Chelan County Public Works Department

Addendum No. 1

RE: CRP 650, Totem Pole Road Phase I Road Improvement Project

Drawing No.	DR1
Sheet No.	21
of Total	48

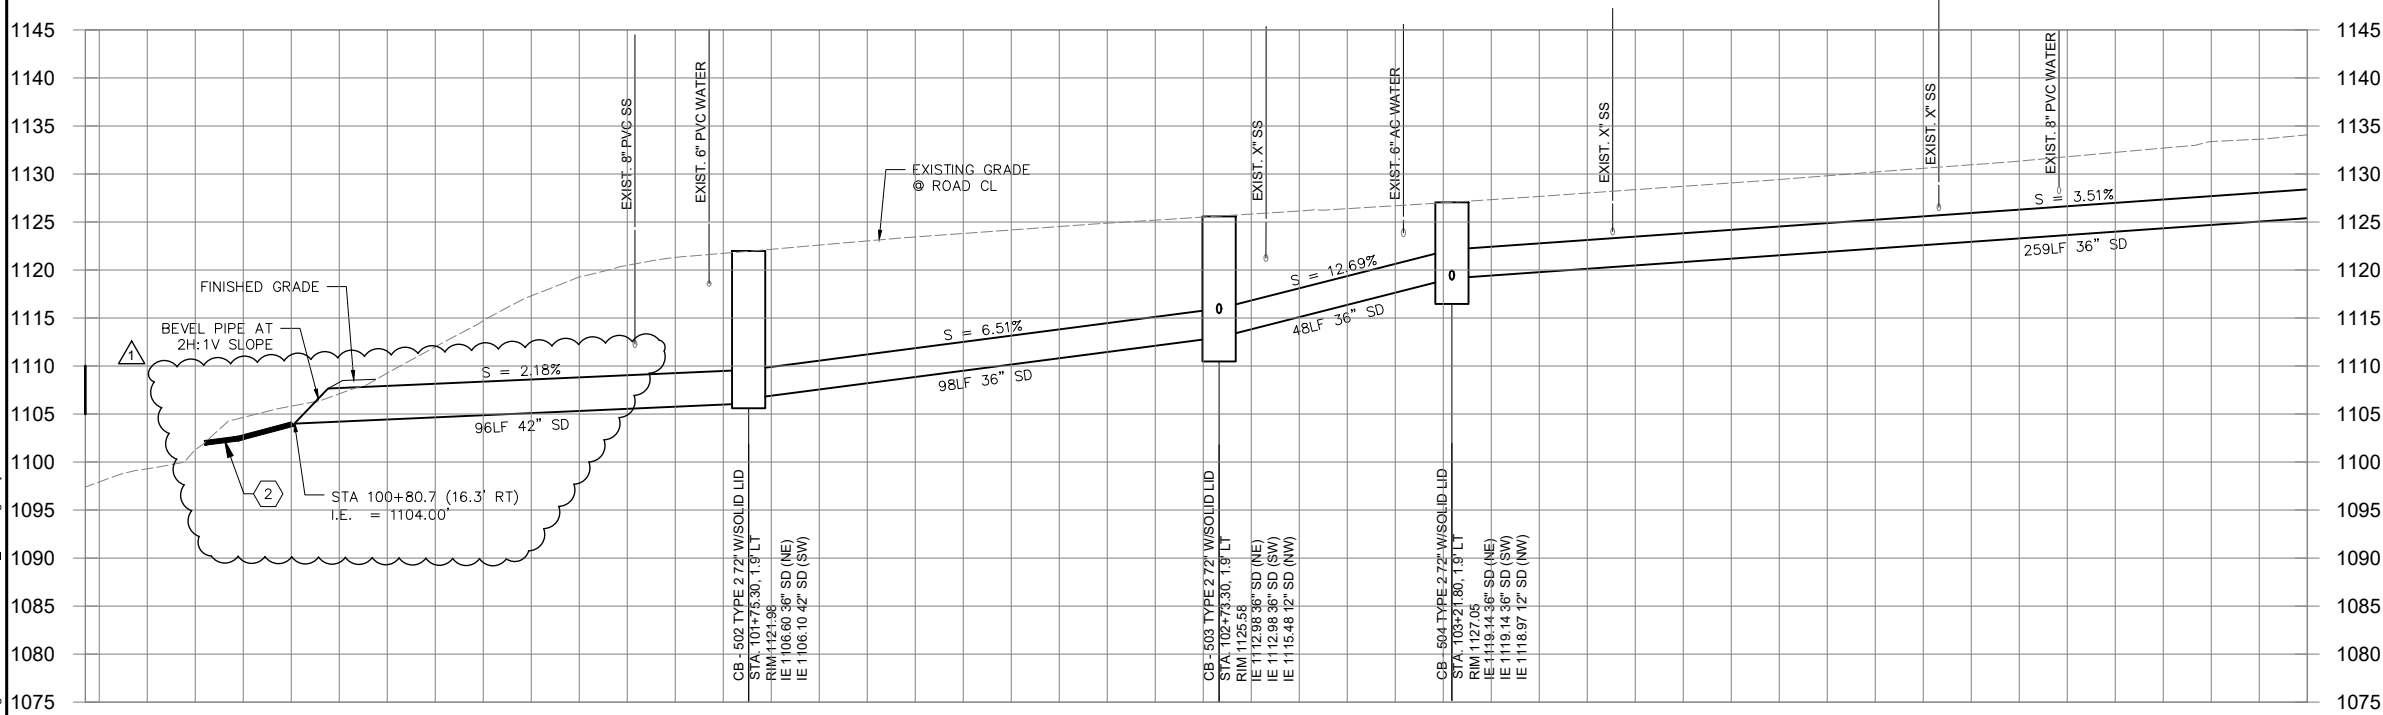
4. Question: Where is the 65' of pipe removal? Plan Sheet 21 shows the pipe removal end, but where is the beginning?

Answer: The 65' of pipe removal is intended to remove the existing pipe from the location shown as "end" down to the existing outfall into Lake Chelan.
